**PLEASANT PRAIRIE PLAN COMMISSION MEETING
VILLAGE HALL AUDITORIUM
9915 39th AVENUE
PLEASANT PRAIRIE, WISCONSIN
6:00 P.M.
APRIL 14, 2014**

Consider the request of Mark Molinaro, Jr. of Partners In Design Architects, agent on behalf of the Hospice Alliance Foundation, Inc. for approval of **Site and Operational Plans** to expand the parking for their facility located at 10220 Prairie Ridge Blvd.

HOSPICE ALLIANCE PARKING LOT EXPANSION
 Pleasant Prairie, Wisconsin
Architectural Site Plan

CERTIFIED SURVEY MAP No. _____

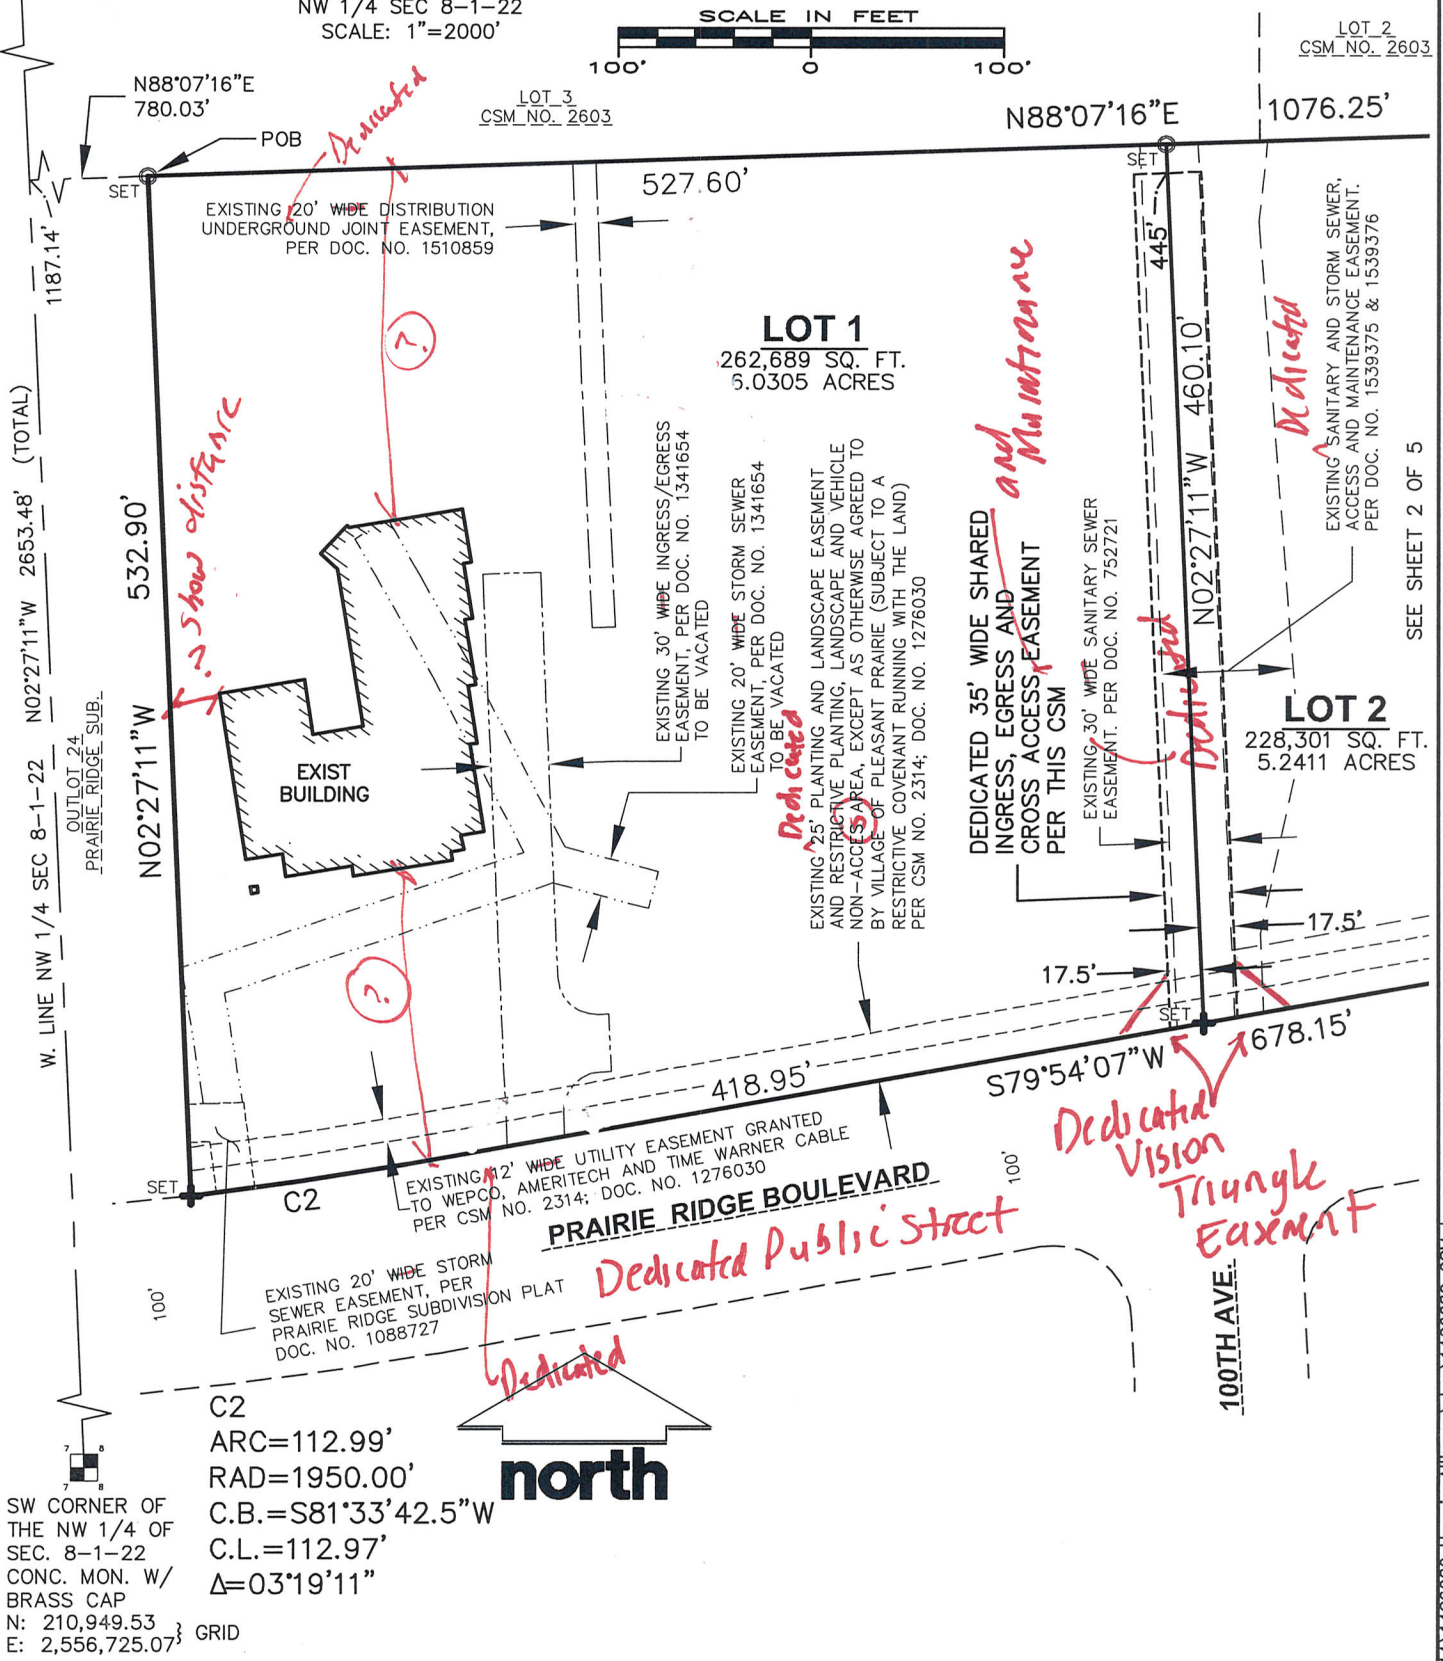
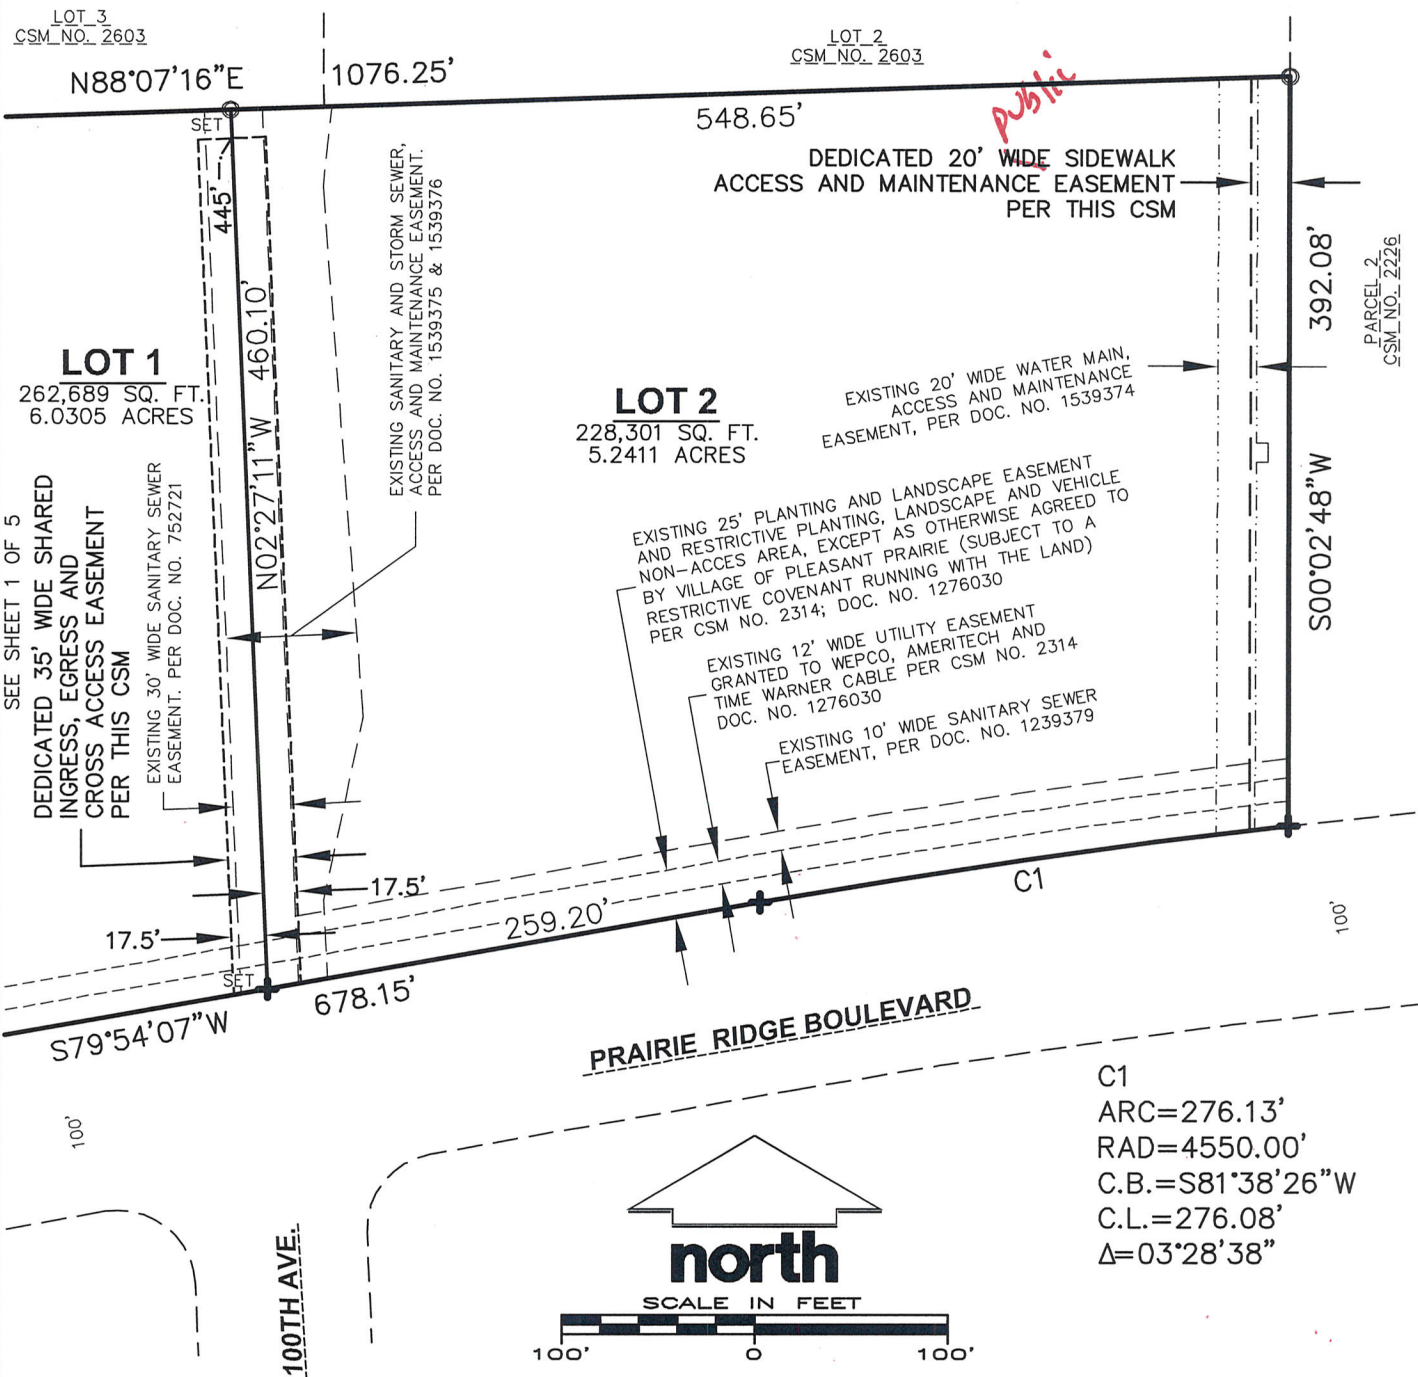
1. The changes as noted on the **attached** CSM and in the staff comments shall be made and a revised draft shall be submitted to the Village staff for review. Additional dedication and easement language shall be added to the CSM as noted.
2. Any outstanding taxes or special assessments shall be paid in full prior to executing and recording the CSM at the Kenosha County Register of Deeds Office.
3. The CSM shall be executed and recorded and a recorded copy provided to the Village within 30 days of Village Board approval.

add missing Dedication Language

ARCHITECTURAL SITE PLAN
1" = 40'-0"

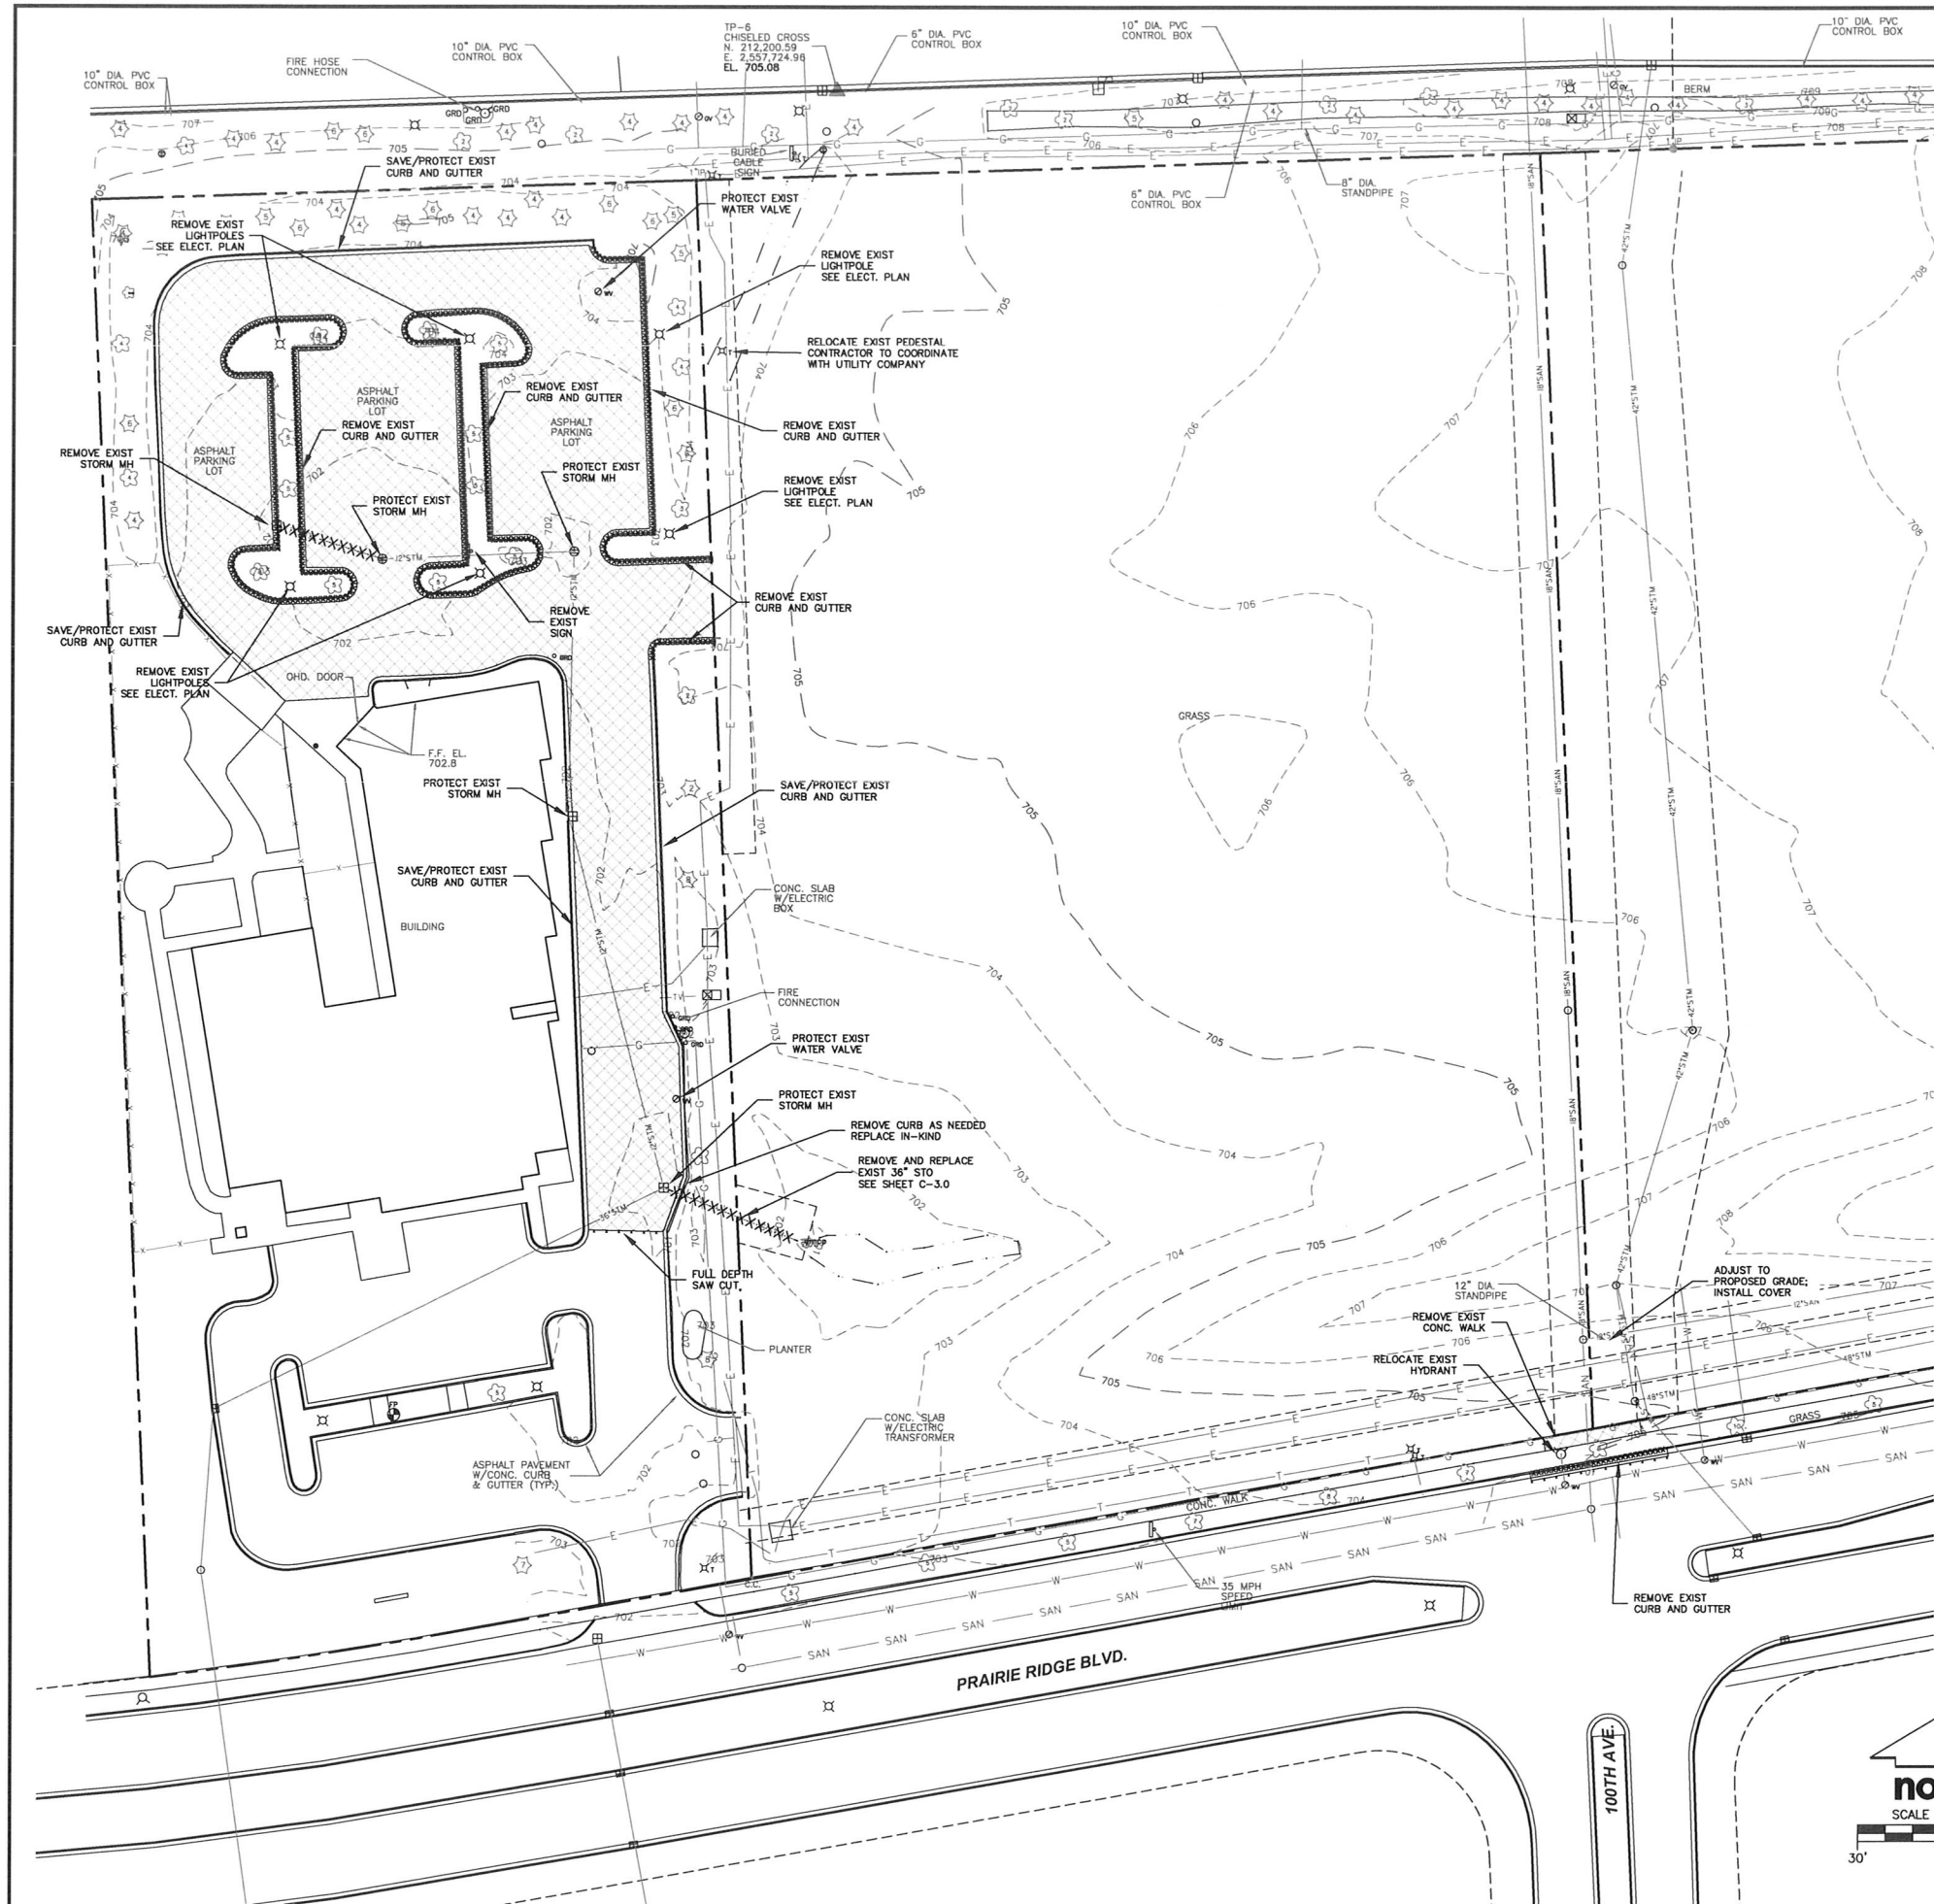
- c. Dimension the setback of the newly proposed parking lot to the north property line.
 - d. Plan Sheet A1.1 depicts curb and gutter along the south side of the new east parking area, while Plan Sheet C-4.0 depicts no curb and gutter in this location due to the possible construction of "25 future parking spaces". Either this area needs to be curbed and guttered with the construction of the expanded parking,
